# MANUAL CHANGES

**Model Number:** 8690B  
**Date Printed:** May 1972  
**Part Number:** 08690-90018

This supplement contains important information for correcting manual errors and for adapting the manual to instruments containing improvements made after the printing of the manual.

*P/O Figure 7-3. Frequency Control Section Reciprocal Amplifier*

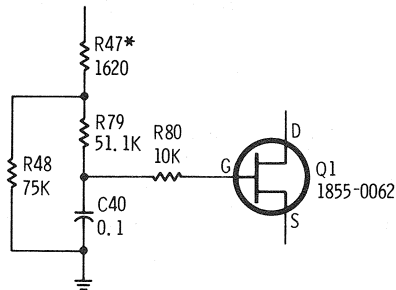
- ▶ Change the A3 Assembly Resistor Reference Designations to read R30-34, 40-45, 47-80.
- ▶ Change the circuitry of A3Q1 as shown in the attached drawing:

Component Identification, Assembly A9

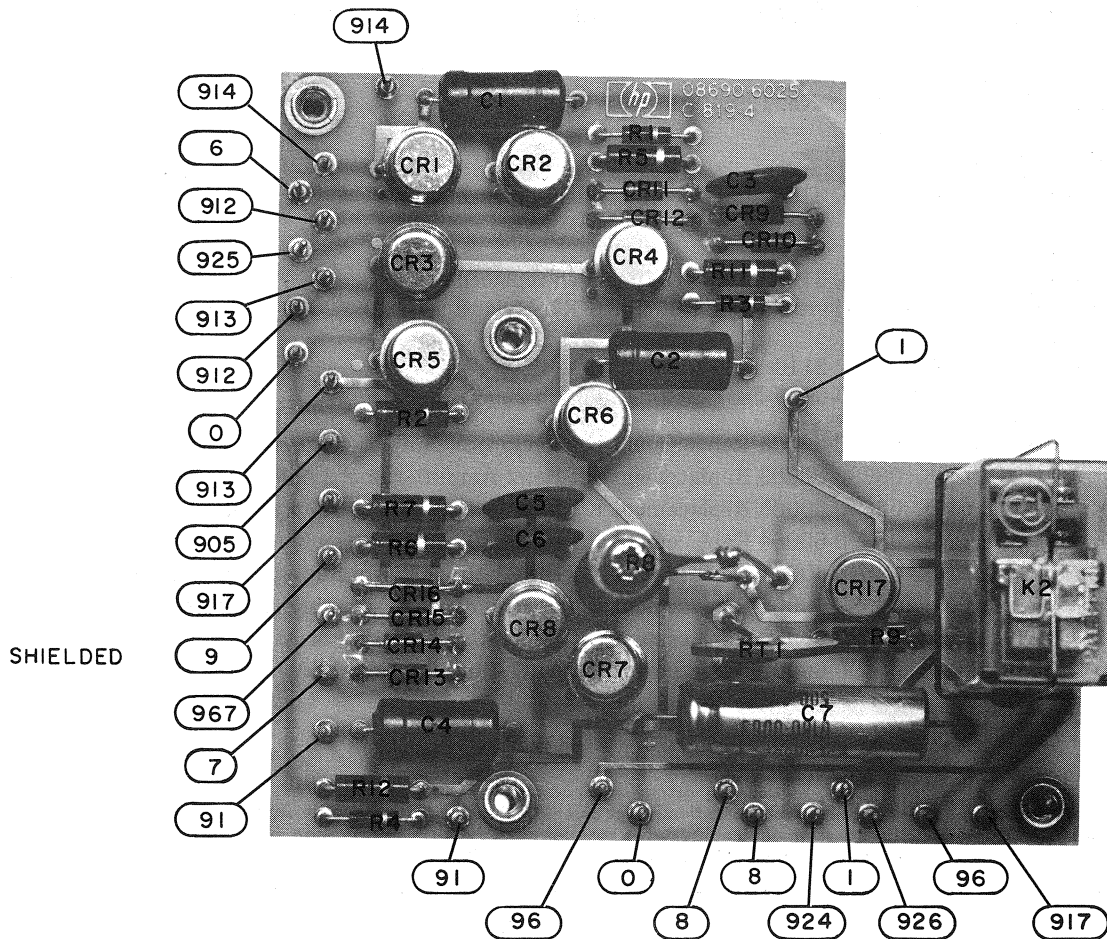
▶ Page 7-14 and 7-16, Component Identification, Assembly A9:

Substitute the attached A9 Component Identification board for that shown in the 8690B Manual.

Figure 1. Component Identification, Assembly A8 (Part of Change 1)

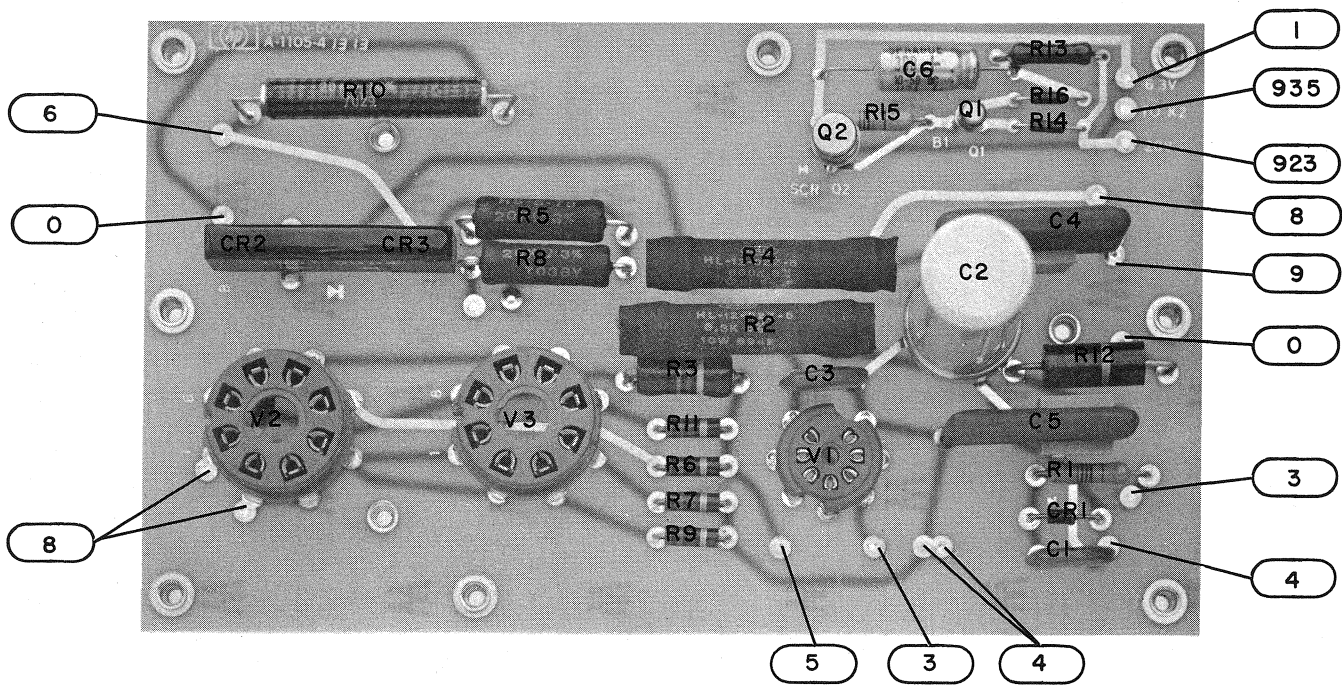
Page 7-14:

Substitute the attached A8 Assy, Component Identification board photo (Figure 1) for the photo shown in the 8690B Manual.

Figure 2. Component Identification, Assembly A14 (Part of Change 2)

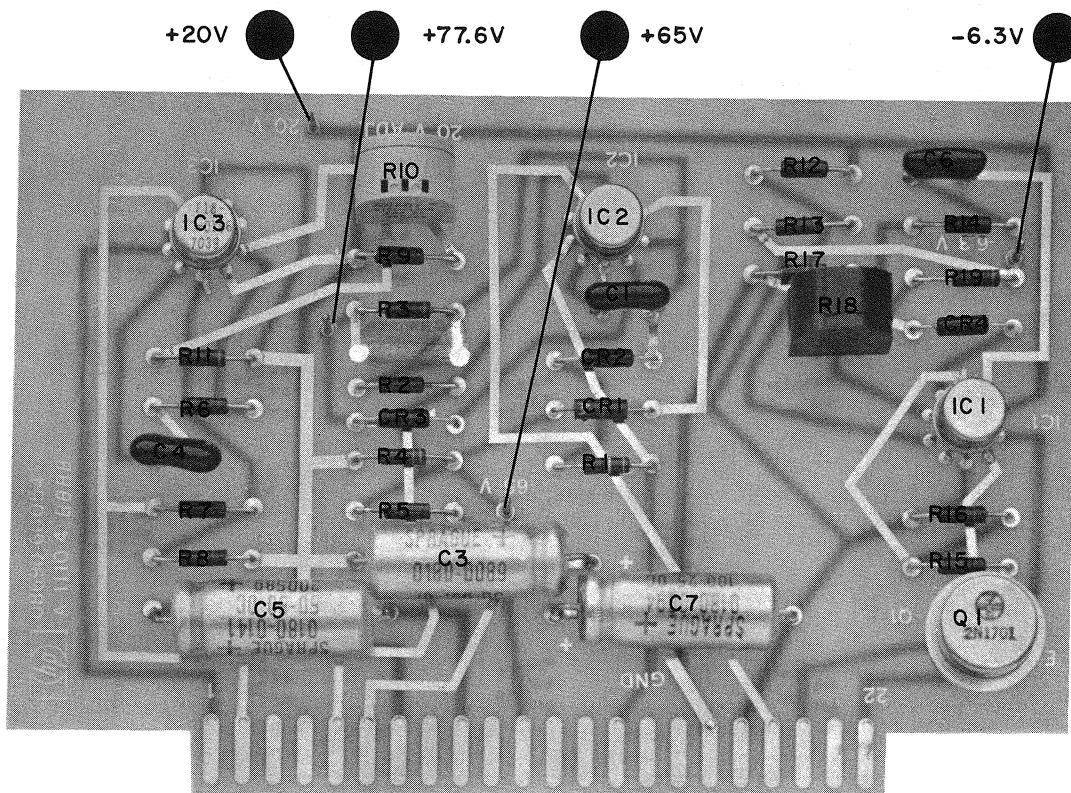
Page 7-14/7-15, Component Identification photo and Figure 7-8:

Substitute the attached A14 Assy board photo and schematic (Figures 2 and 3) for those shown in the 8690B Manual.

Figure 4. Component Identification, Assembly A4 (Part of Change 5)

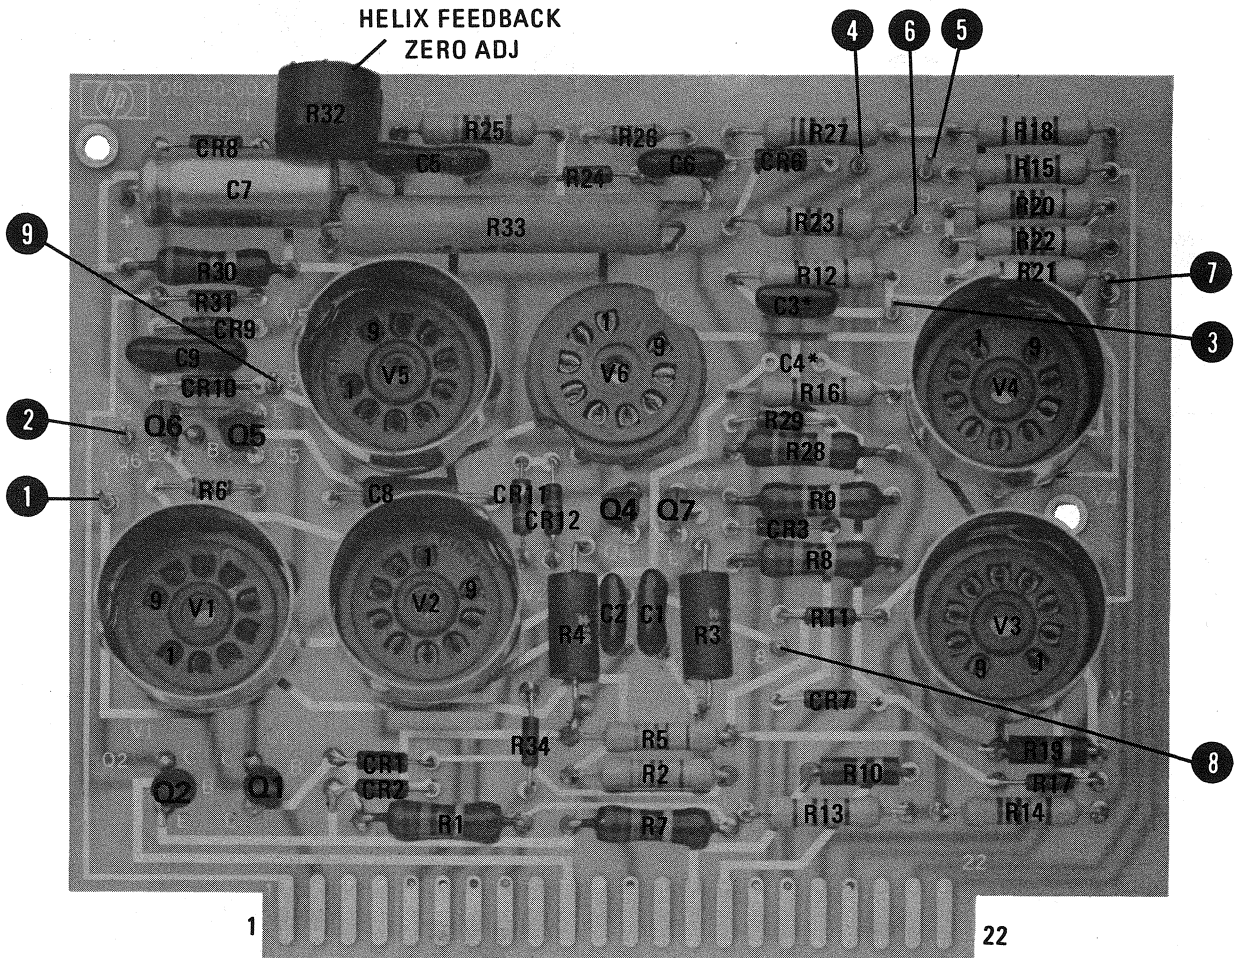
Page 7-9, Figure 7-5:

Add diode A4CR12 in series with zener diode A4CR11. Connect cathode of A4CR12 to ground, and anode to A4CR11.

Figure 5. Component Identification, Assembly A3 (Part of Change 1)

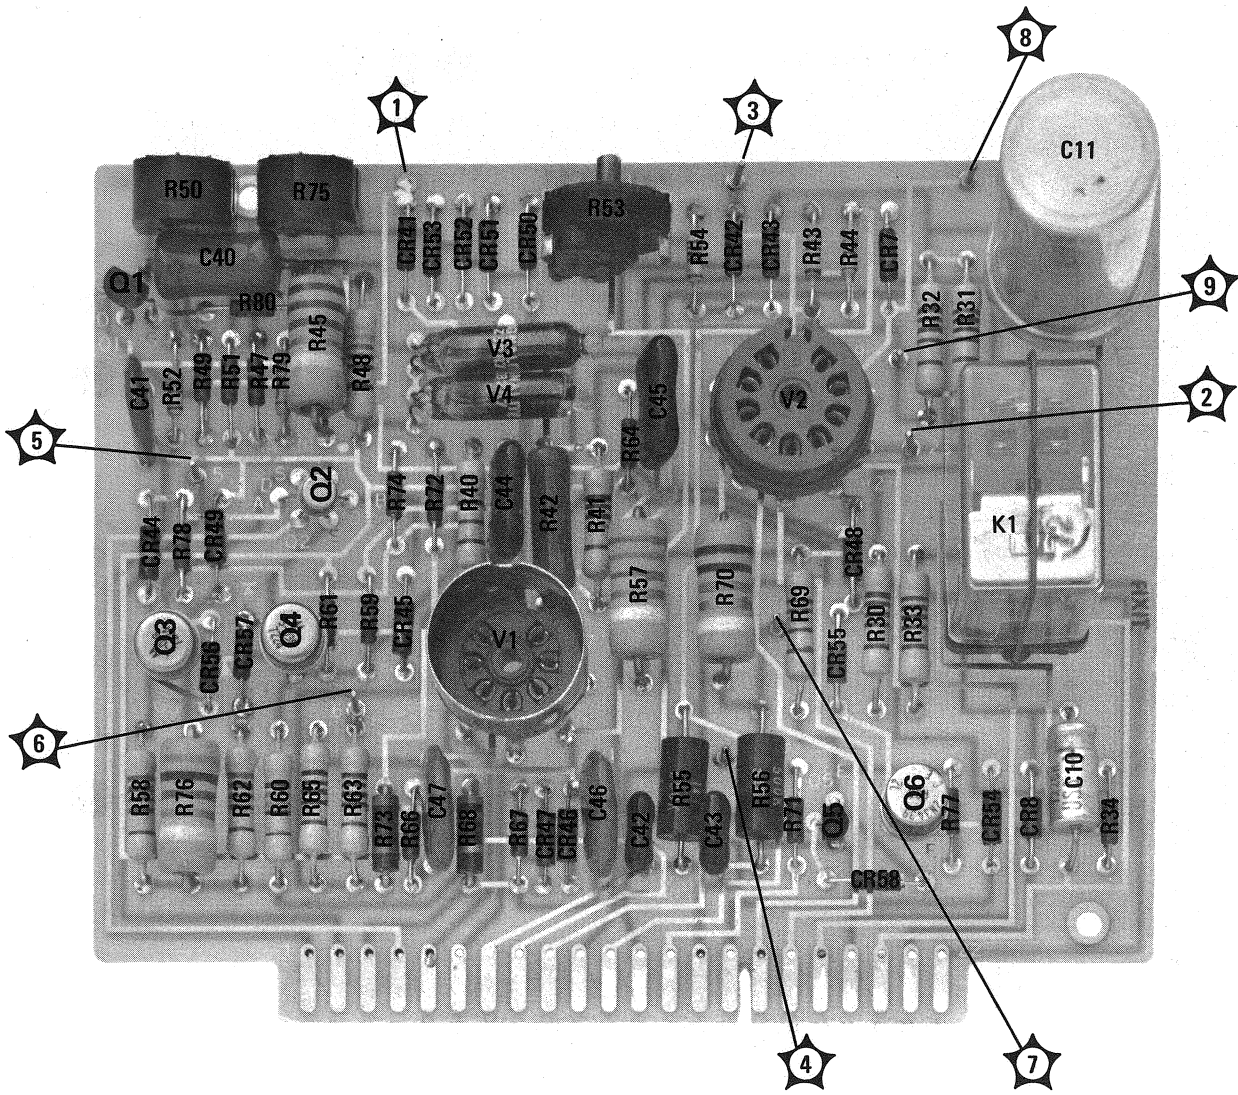
Substitute the attached Component Identification Assembly A3 board photo (Figure 5) for the photo shown in the manual.
